FOOD SERVICE PLAN REVIEW APPROVED

1538.00
An Interior Renovation for:
SWEET BREWNETTE
13999 GULF BLVD., SUITE C-2
MADEIRA BEACH, FL

SUBMIT TITLE
EQUIPMENT PLAN
SUBMIT NUMBER
A-5

SHEET TITLE
 LIFE SAFETY PLAN

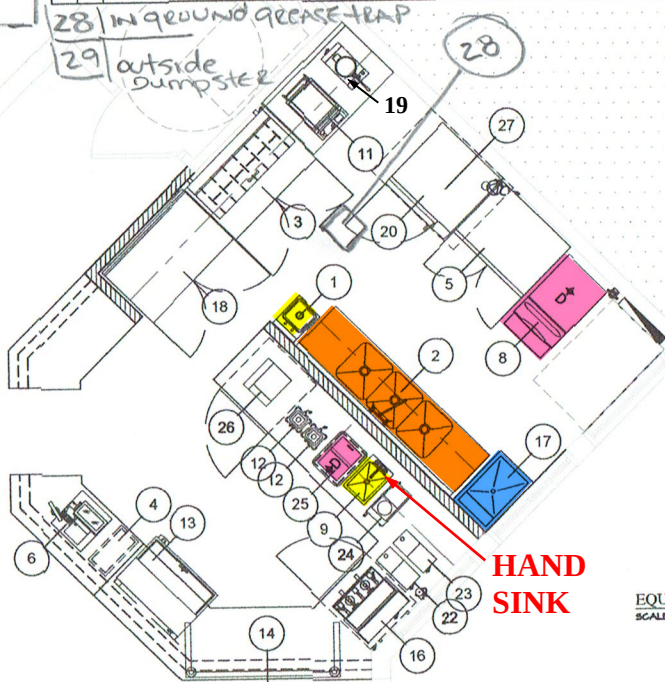
Plans are in compliance subject to:

- 1) Connection to approved water and wastewater systems.
- 2) Compliance with applicable state and local codes.
- 3) Compliance with all provisos on specification worksheet.

See Comments on Specification Sheet

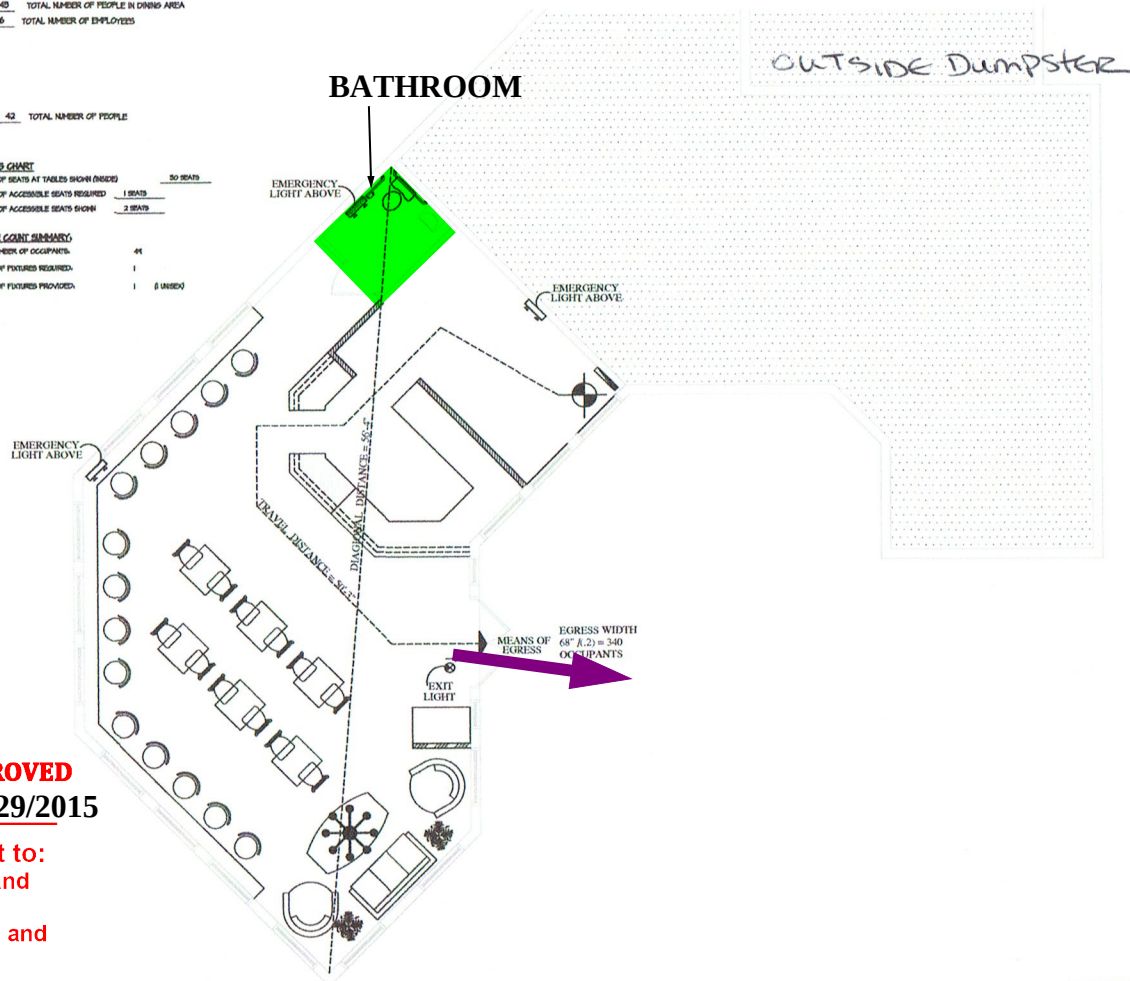
Plans are in compliance subject to:

- 1) Connection to approved water and wastewater systems.
- 2) Compliance with applicable state and local codes.
- 3) Compliance with all provisos on specification worksheet.

See Comments on Specification Sheet
